RHODE ISLAND DEPARTMENT OF TRANSPORTATION

RHODE ISLAND CONTRACT NO.2015-CH-010

ADA Improvements to Downtown Providence (Contract 3)

ADDENDUM NO. 2 Prospective bidders and all concerned are hereby notified of the following changes in the Plans, Specifications, Proposal and Distribution of Quantities for this contract. These changes shall be incorporated in the Plans, Specifications, Proposal and Distribution of Quantities, and shall become an integral part of the Contract Documents.

SERVICE DETAIL "A"
NOT TO SCALE

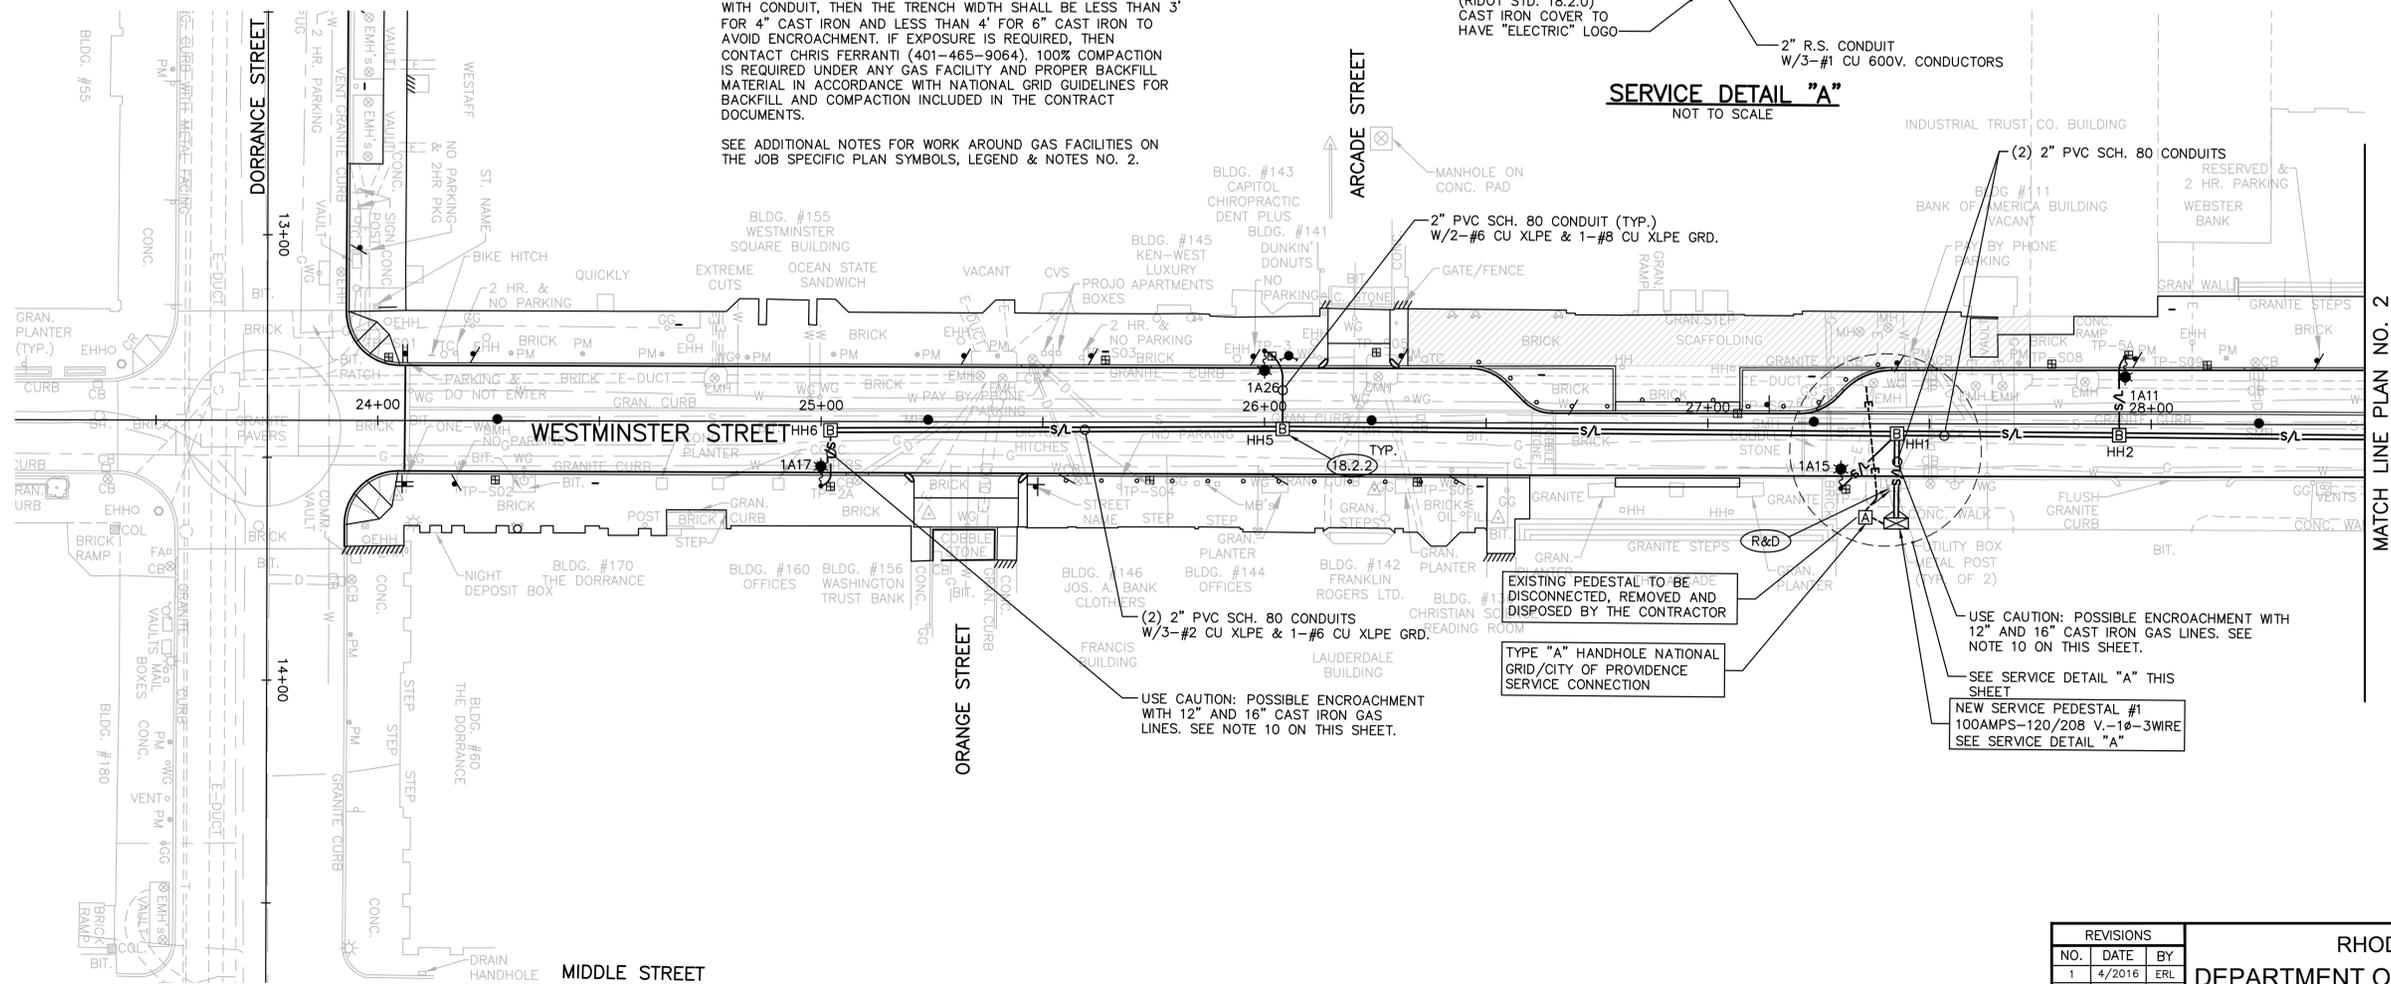
Delete Sheet No. 50 – Lighting Plan No. 1 in its entirety and replace it with Sheet No. 50 – Lighting Plan No. 1 (R-1) attached to this Addendum No. 2. The Service Detail “A” has been revised.

LIGHTING DETAILS
SHEET NO. 1

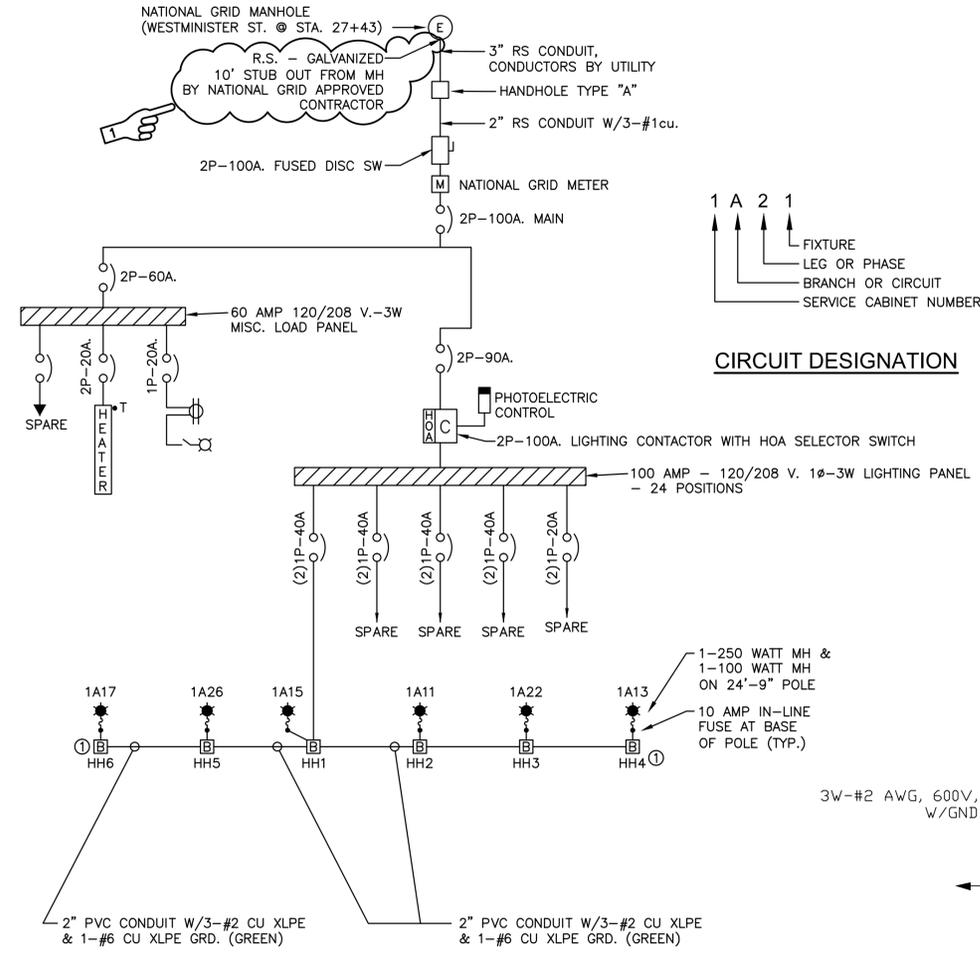
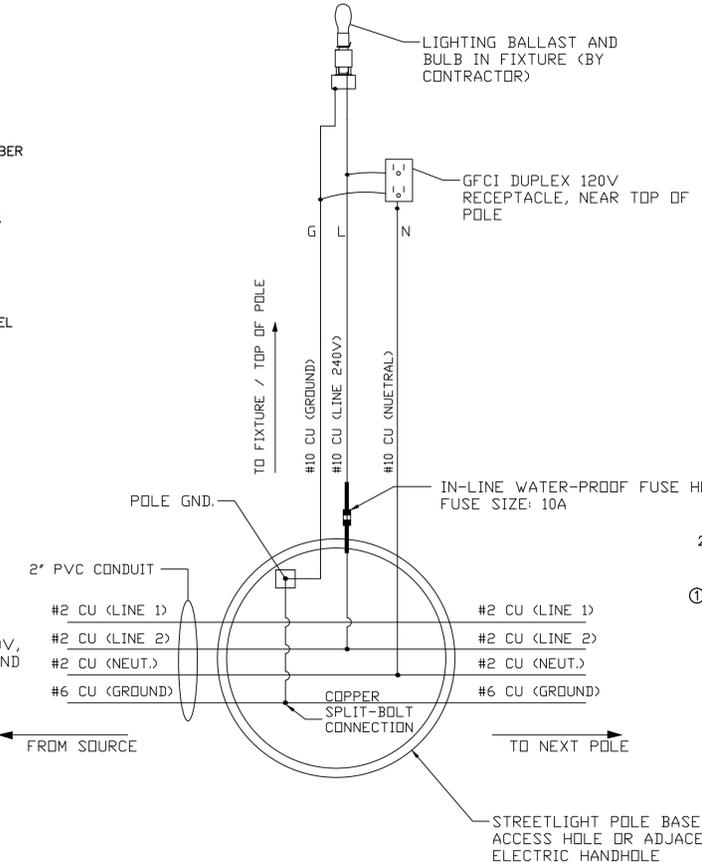
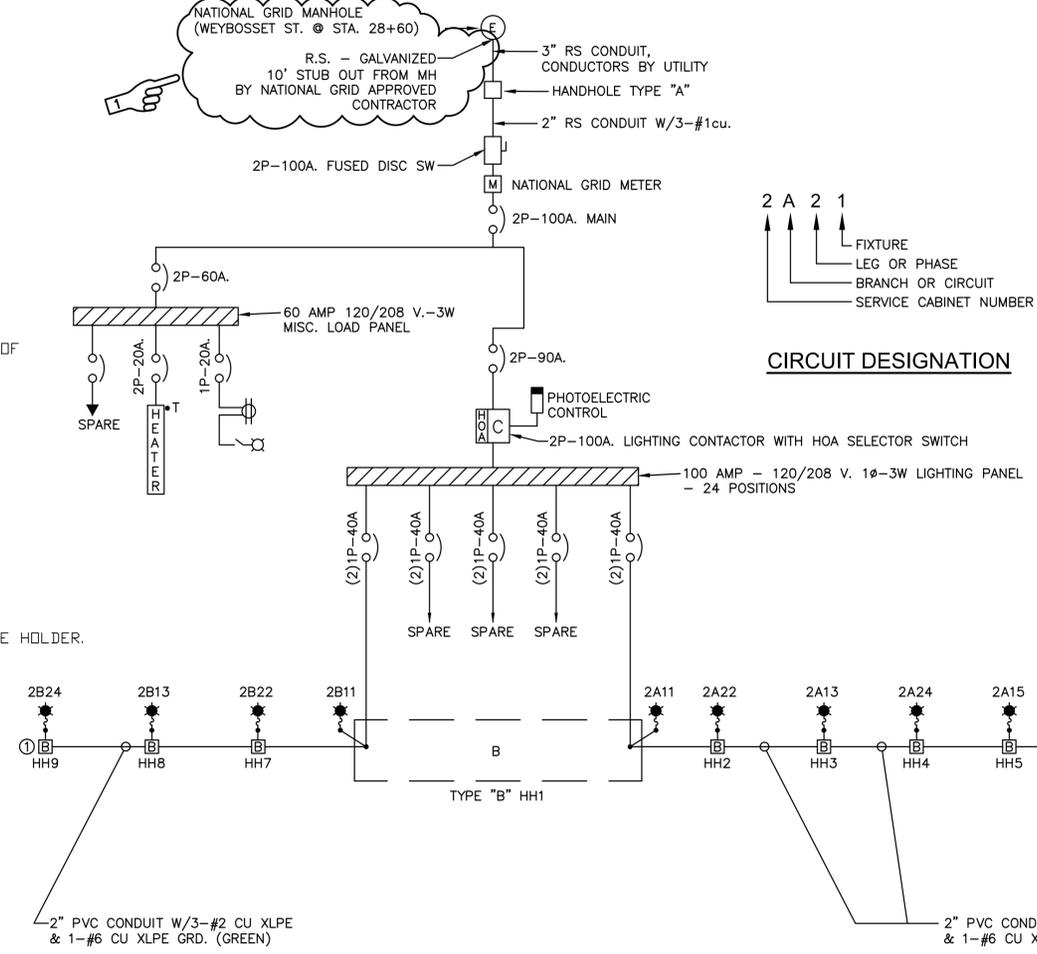
Delete Sheet No. 53 – Lighting Details Sheet No. 1 in its entirety and replace it with Sheet No. 53 – Lighting Details Sheet No. 1 (R-1) attached to this Addendum No. 2. The wiring diagrams have been revised.

SERVICE PEDESTAL FOUNDATION DETAIL
NOT TO SCALE

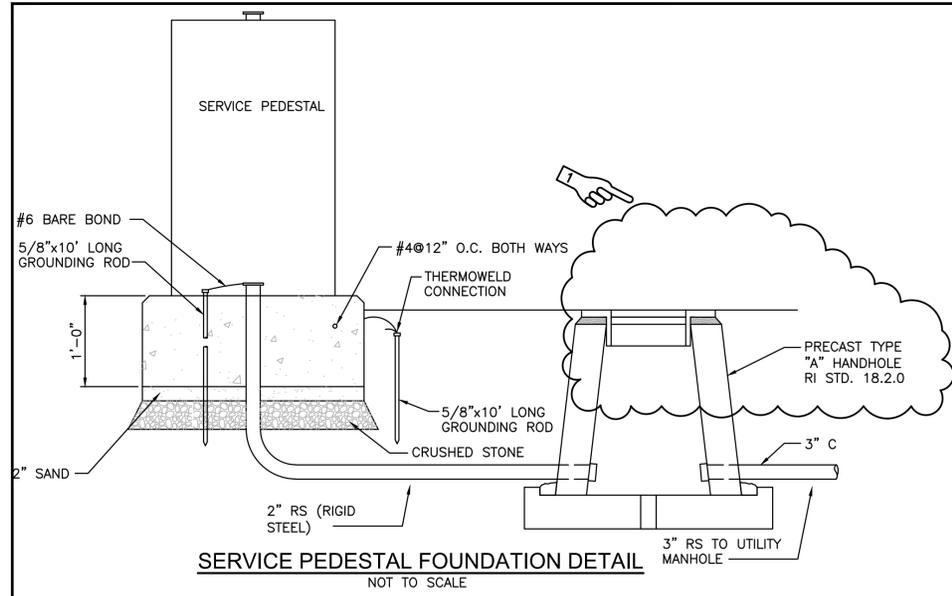
Delete Sheet No. 55 – Lighting Details Sheet No. 3 in its entirety and replace it with Sheet No. 55 – Lighting Details Sheet No. 3 (R-1) attached to this Addendum No. 2. The Service Pedestal Foundation Detail and Service Pedestal – 120/208 Volts – 1Ø – 3W detail have been revised.
